**FINAL DRAINAGE REPORT  
FOR  
VOLLMER SUBSTATION  
EL PASO COUNTY, COLORADO**

**JUNE 2019**

TNE Job No. 1845.00

PPR2147

DEVELOPED DRAINAGE MAP

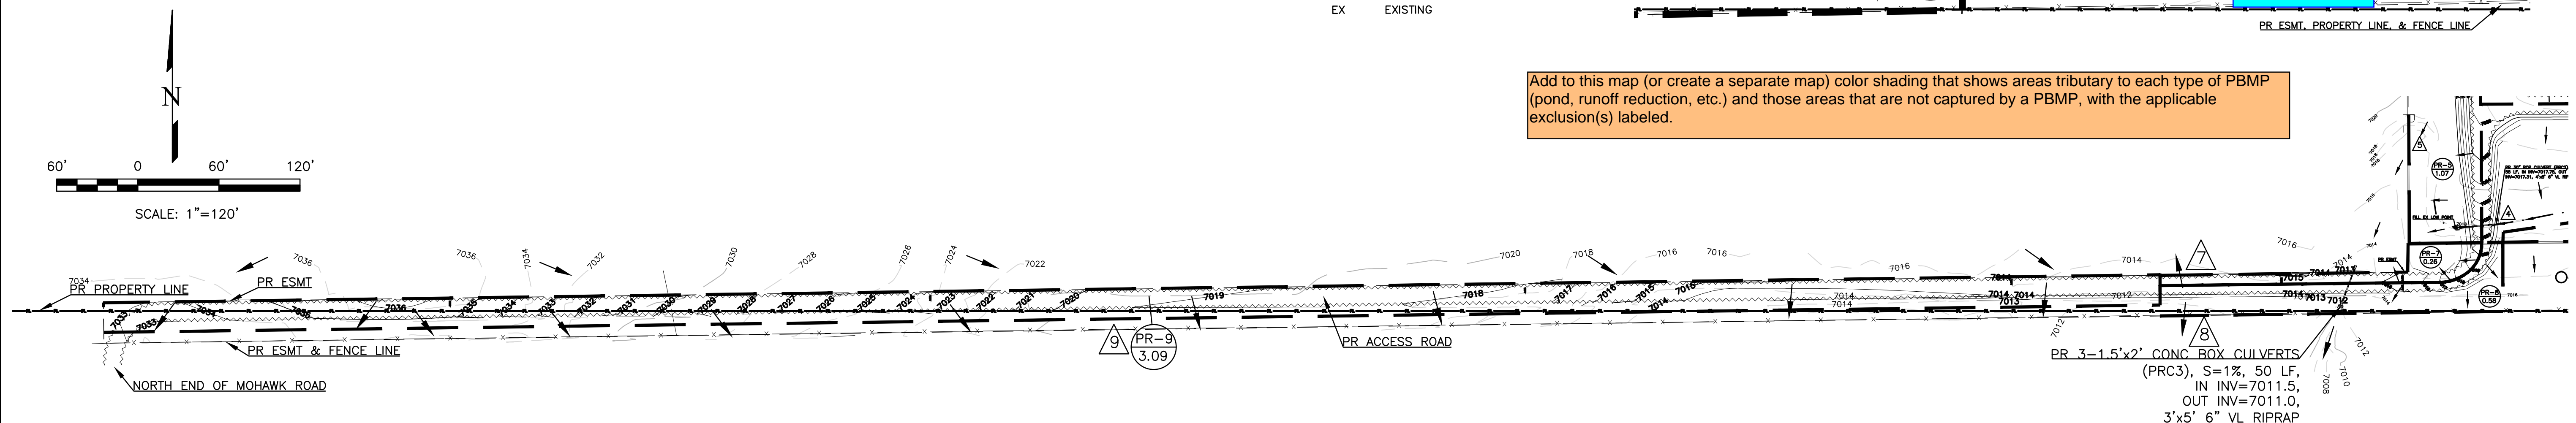
Add to this map (or create a separate map) color shading that shows areas tributary to each type of PBMP (pond, runoff reduction, etc.) and those areas that are not captured by a PBMP, with the applicable exclusion(s) labeled.

I PUT IT ON THE EXISTING CONDITIONS MAP.  
THIS IS A NATURAL SWALE, SO THE SECTION  
IS A GENERALIZATION AT BEST. IT'S ALSO THE  
SAME SECTION THAT'S IN THE CALCS.

VOLLMER SUBSTATION  
EL PASO COUNTY, CO  
WATER QUALITY DETAILS  
SEPTEMBER 2018

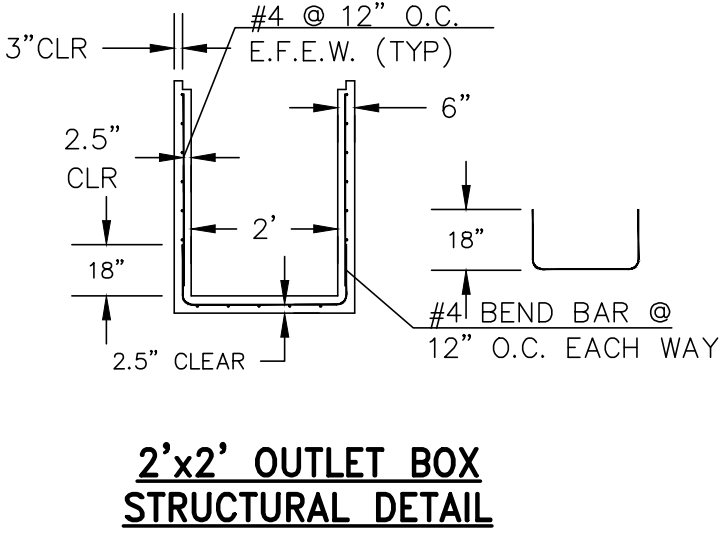
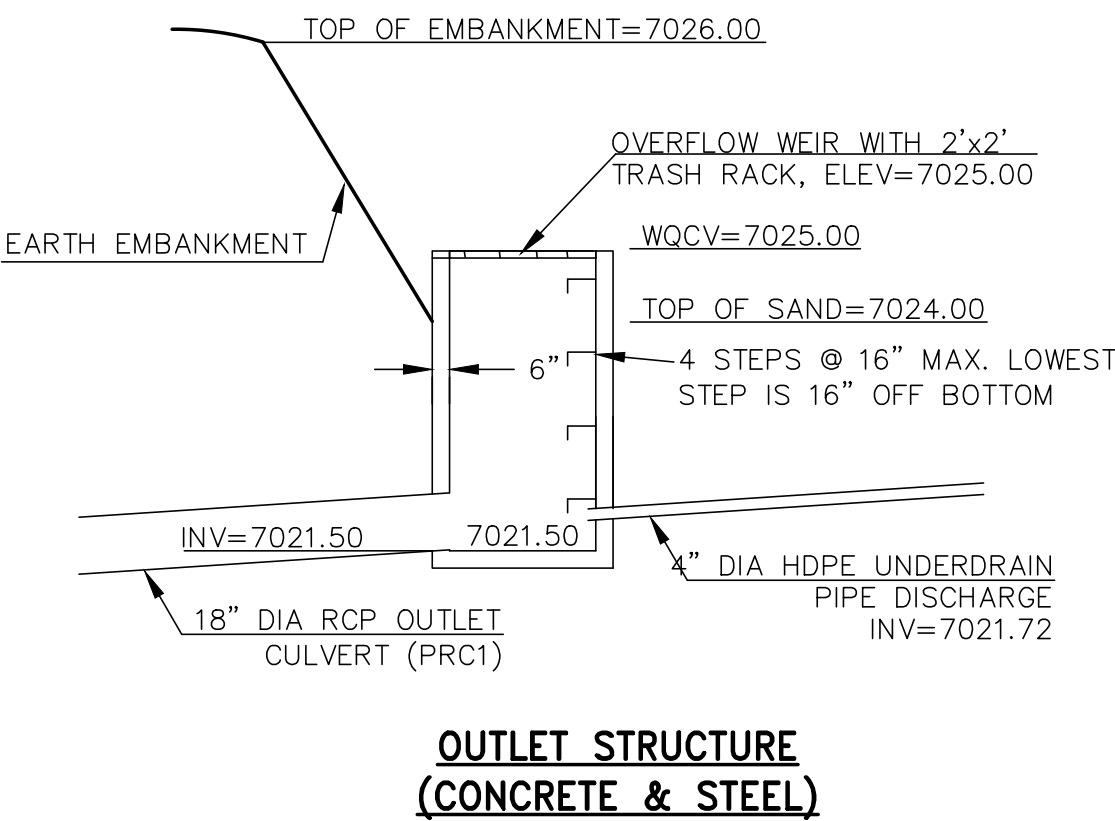
Please show a cross section of the sand filter basin spillway.
